REMARKS

Appl. No. 09/896,695  
Amdt. Dated 10/20/2003  
Reply to Office Action of 06/20/2003

## METHOD AND APPARATUS FOR PUSH BUTTON RELEASE FIBER OPTIC MODULES

FIG. 8A

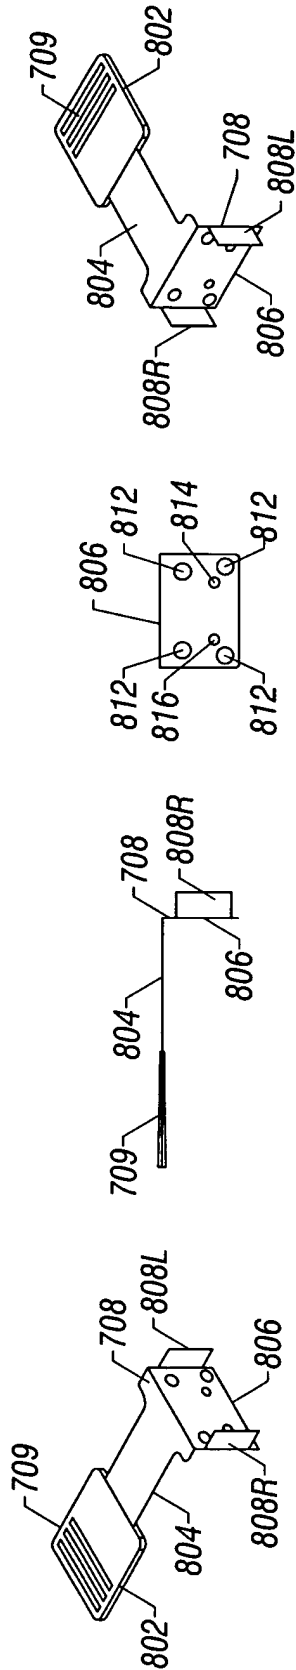
Figure 8A, Applicant has deleted the text "EMI SHIELD" from the drawing.

FIG. 8D

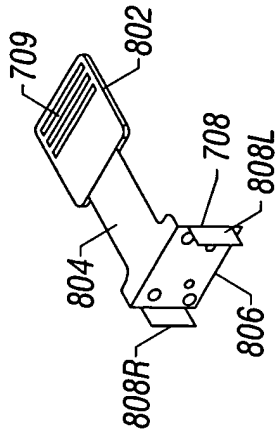
Figure 8D, Applicant has deleted the text "FLEXIBLE ARM" from the drawing.

FIG. 10A

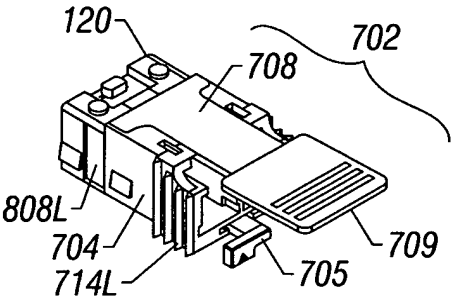
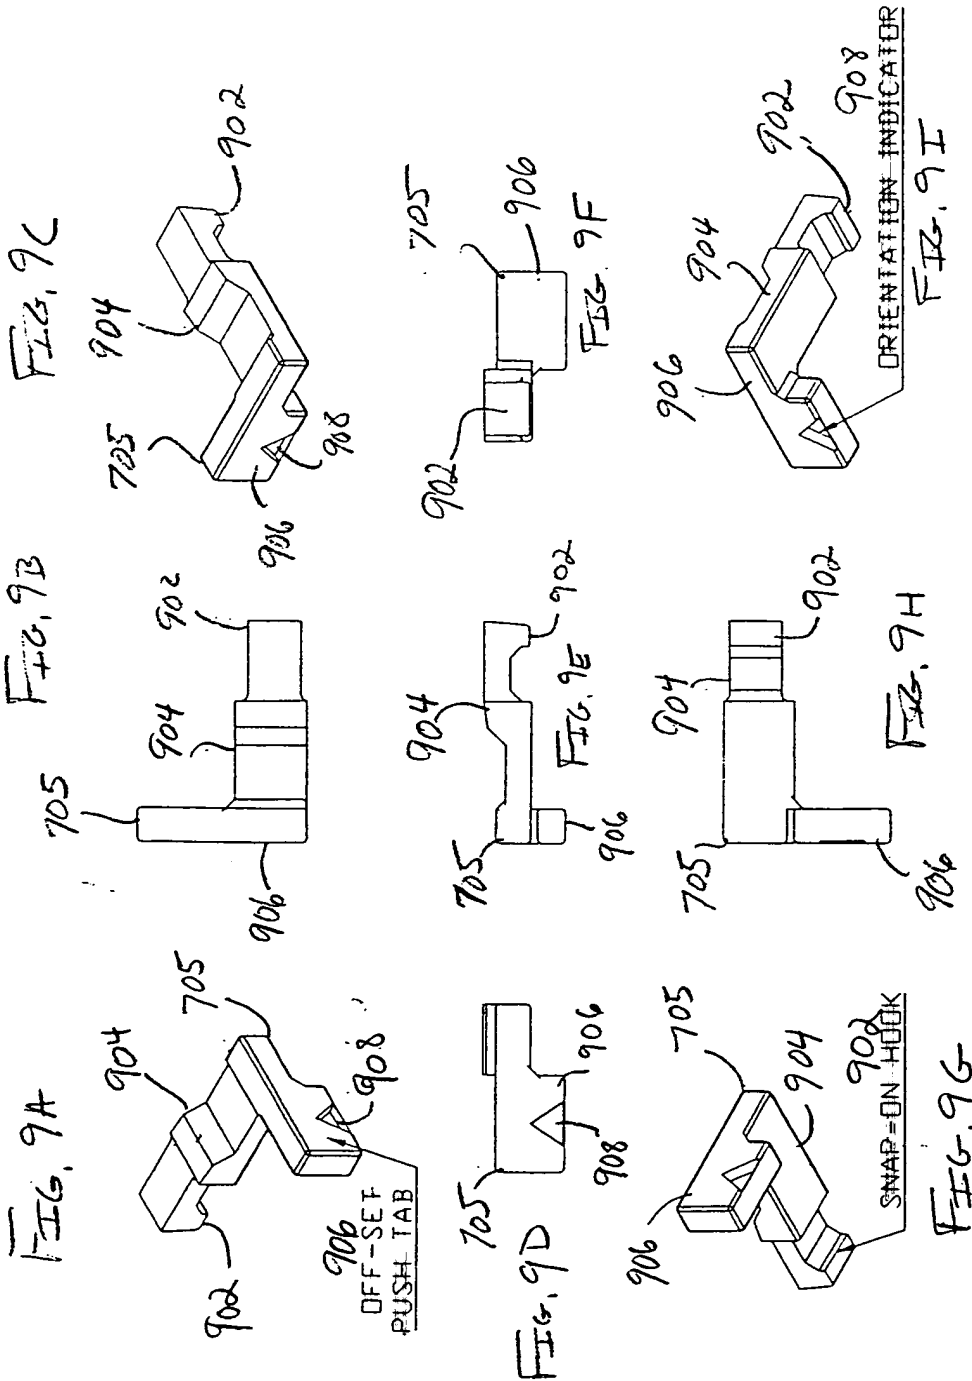
Figure 10A, Applicant has deleted the text "(1) ACTUATOR-KICKER" from the drawing.

FIG. 10D

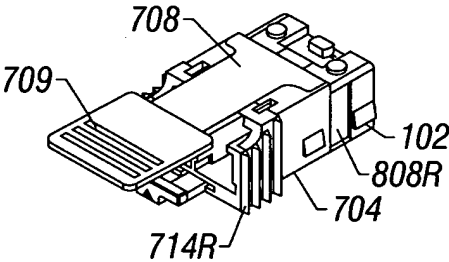
Figure 10D, Applicant has deleted the text "(3) NOSE GRIP" from the drawing.

FIG. 10E

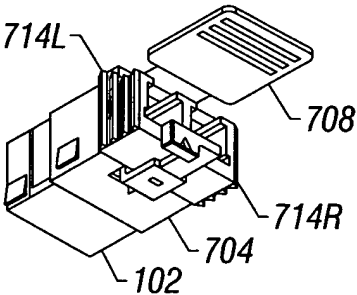
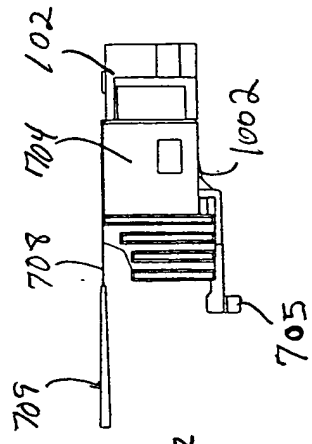
Figure 10E, Applicant has deleted the text "(2) WITHDRAWAL TAB" from the drawing.

FIG. 11C

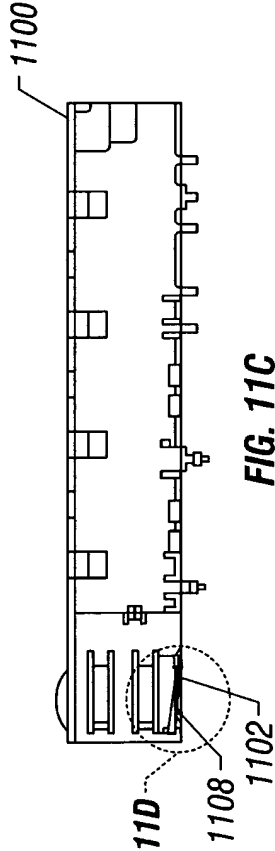
Figure 11C, Applicant has deleted the text "BOTTOM CAGE" and its reference line from the drawing. Applicant has further added a reference number 1108 consistent with the reference number 1108 shown in Figures 11B, 11D, and 11E.

FIG. 18D

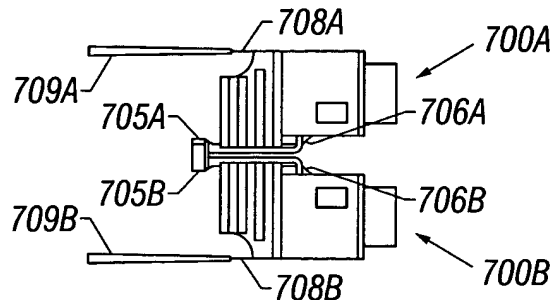
Figure 18D, Applicant has amended a reference number "708A" to --709A-- to correct an incorrect reference number. Reference number 709A is an optional pull grip of the withdraw tab 708A.
